**Subject: Class 1 Permit Modification to Add Structure to the Los Alamos National
Laboratory (LANL) Hazardous Waste Facility Permit, EPA ID #NM0890010515**

Enclosure: *Hazardous Waste Facility Permit Class 1 Permit Modification for Addition of a Structure to Technical Area 63*

Class 1 Permit Modification Addition of a Structure to Technical Area 63, Los Alamos National Laboratory Hazardous Waste Facility Permit

Figure G.27-1. Transuranic Waste Facility Soil Sampling Grid

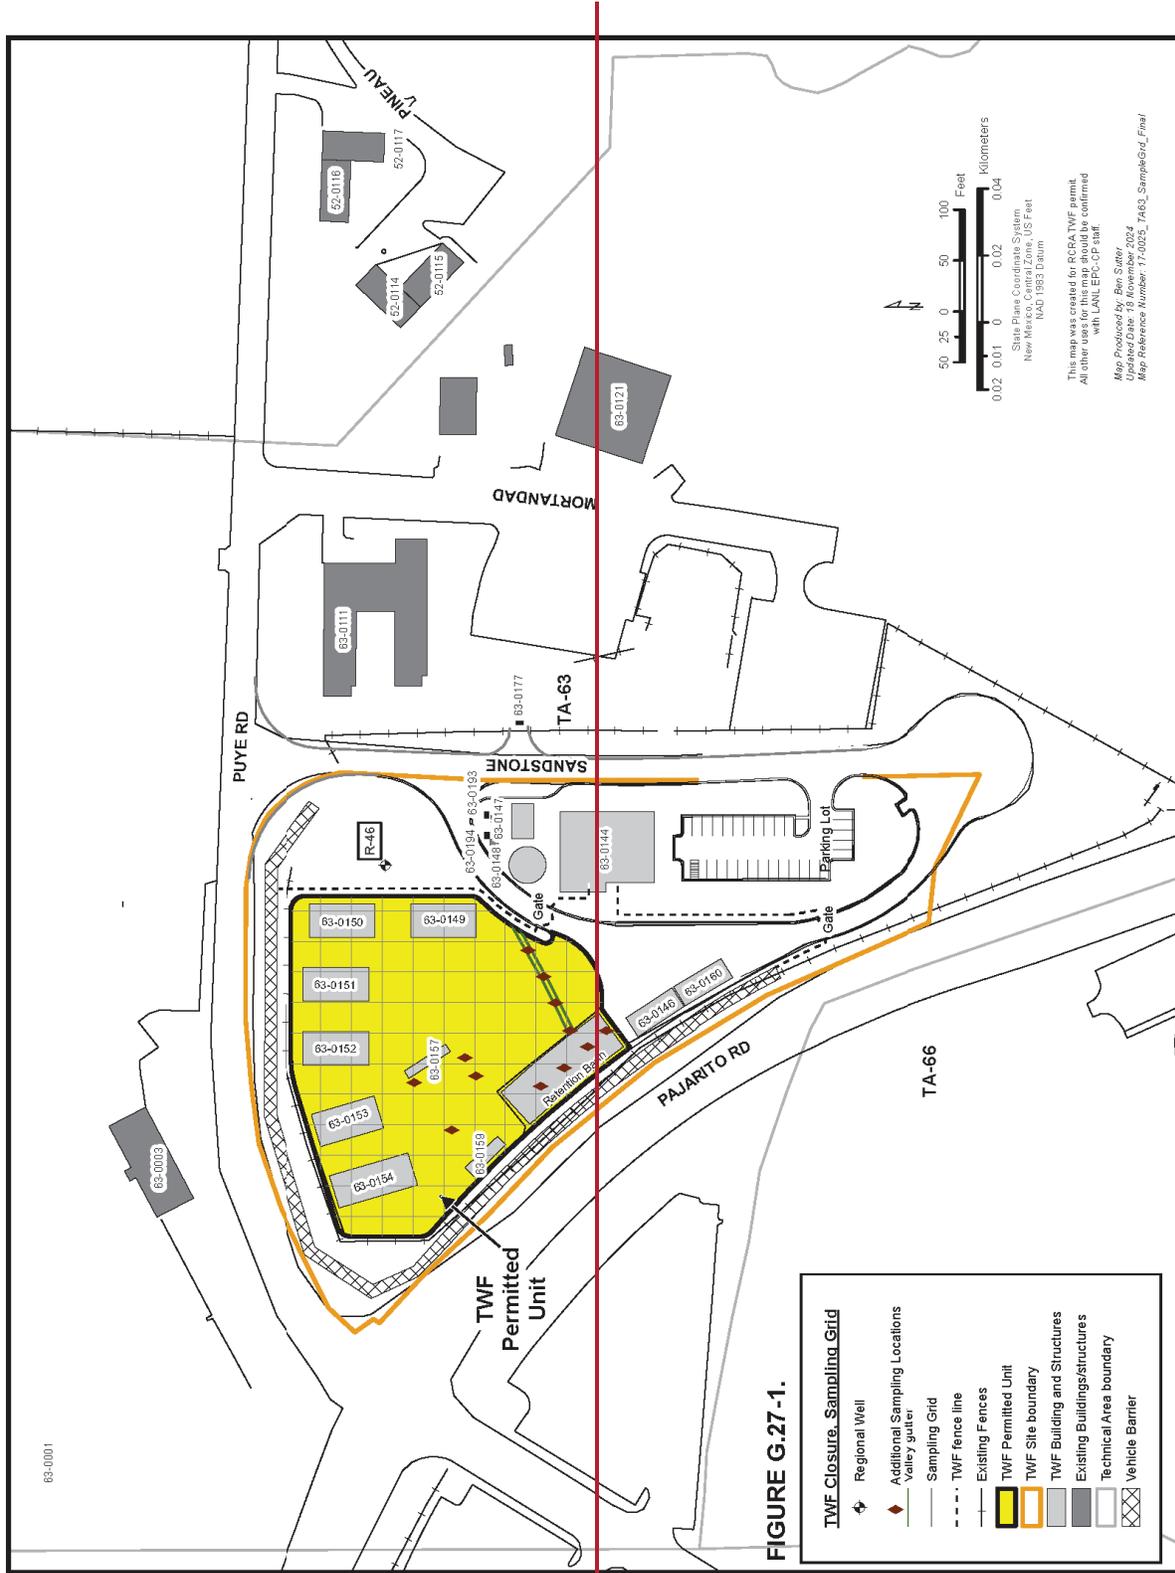
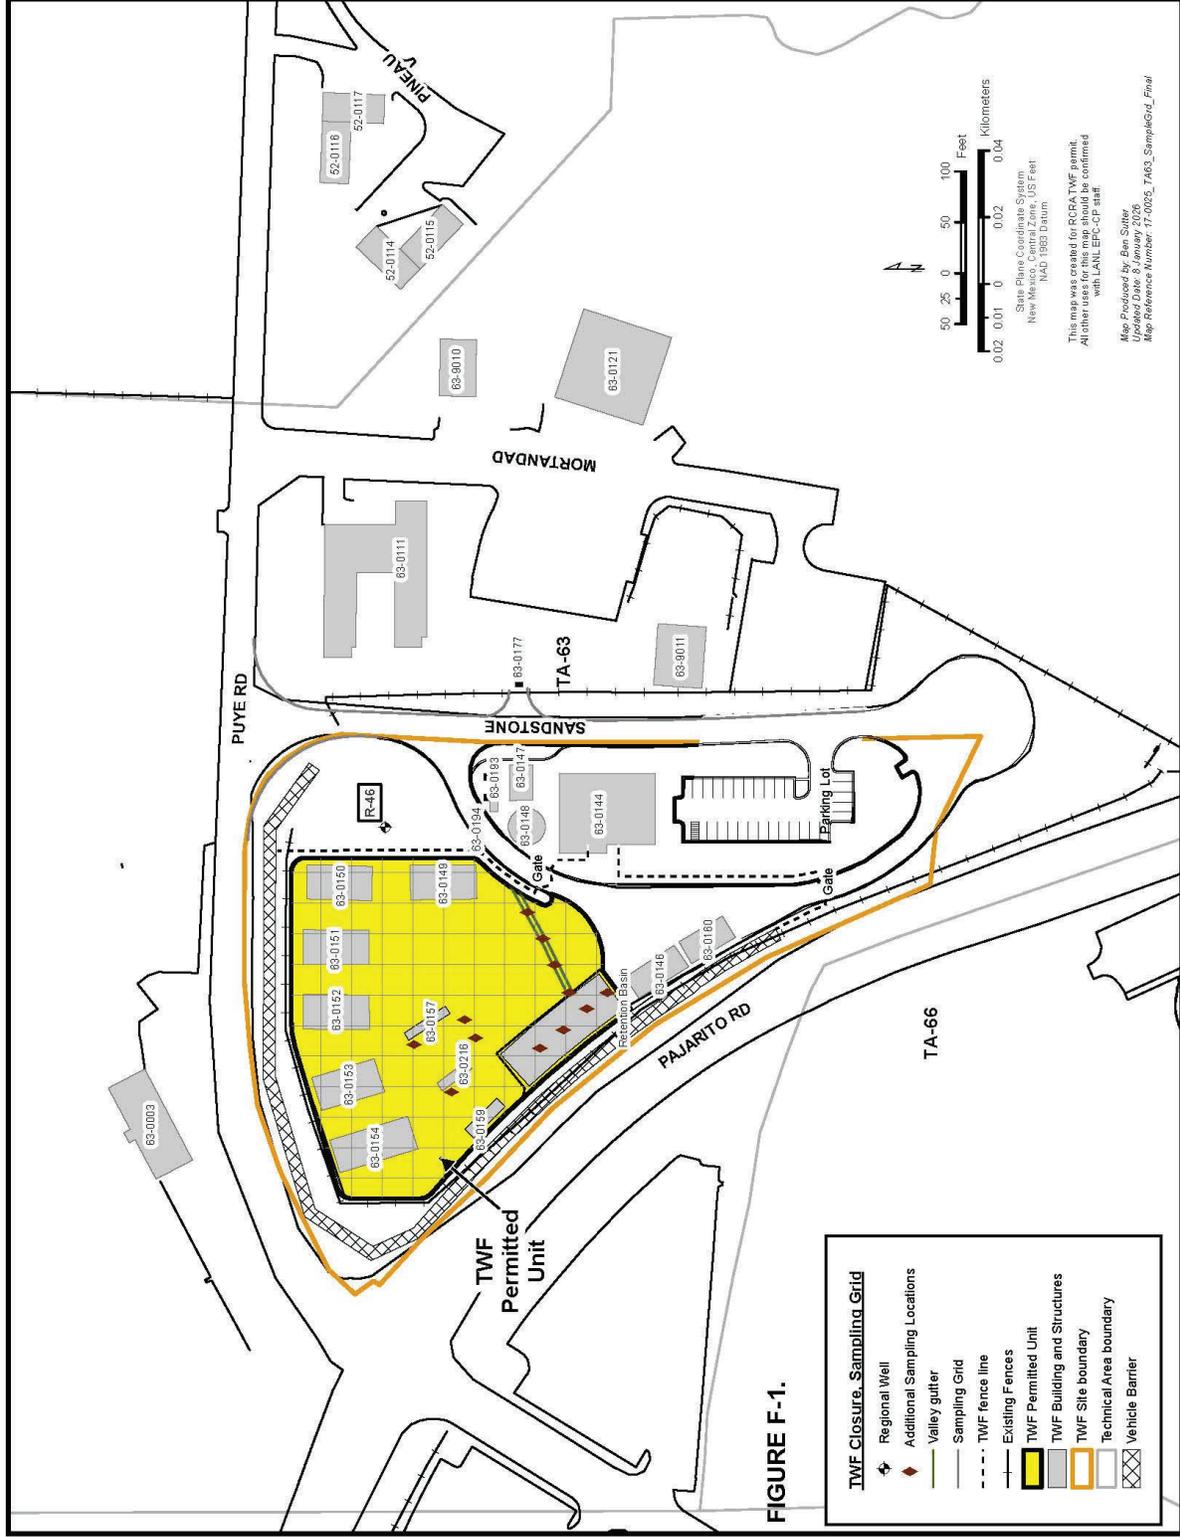
Attachment G.27, Technical Area 63, Transuranic Waste Facility Closure Plan, revision reflects the addition of structure RTR-9 to the description of unit to be closed, a correction of a typographical error for the Calibration Source and Matrix Module building from structure “63-0158” to “63-0159”, and an updated Figure G.27-1 is provided.

Figure 55

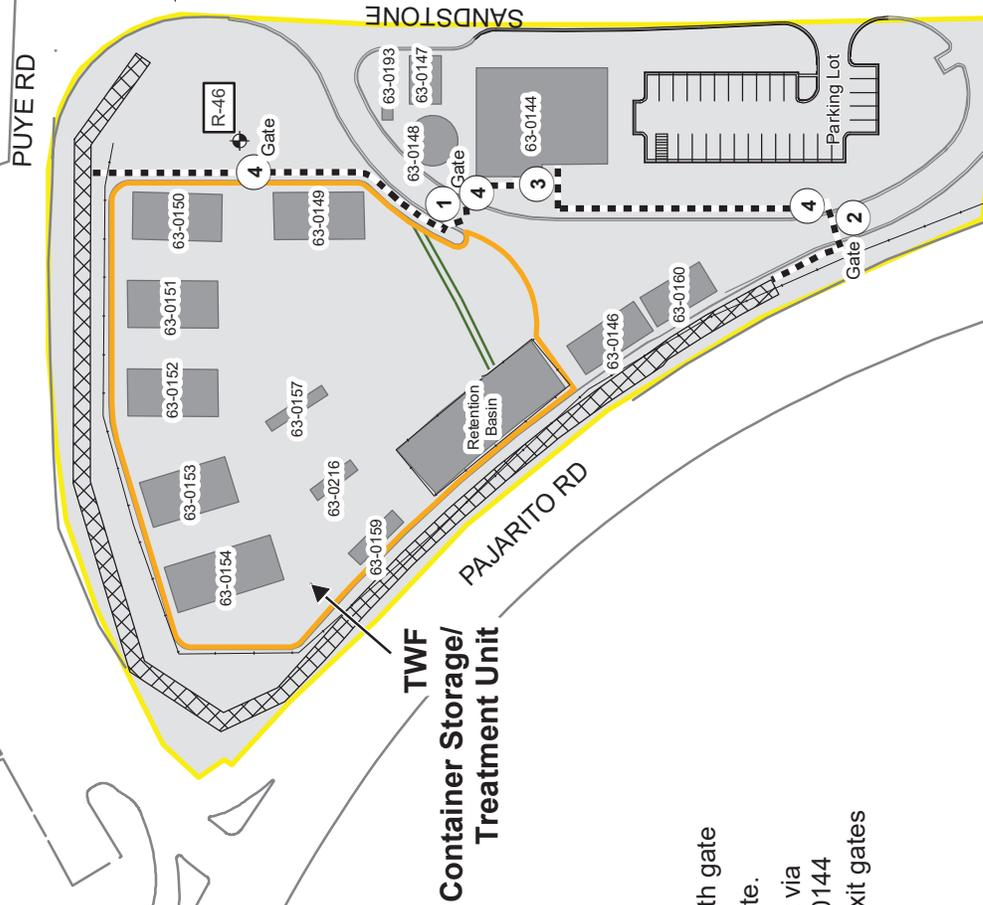
Attachment N, Figures, revision reflects the addition of structure RTR-9 to Figure 55, Technical Area (TA) 63 Transuranic Waste Facility, and Figure 56, Transuranic Waste Facility Subsurface Vapor Monitoring Network. Additional updates were made to Figure 56 to remove the word “proposed” in the legend of the map. Please note that this figure has been recreated by the Permittees, as the original was not generated in house.
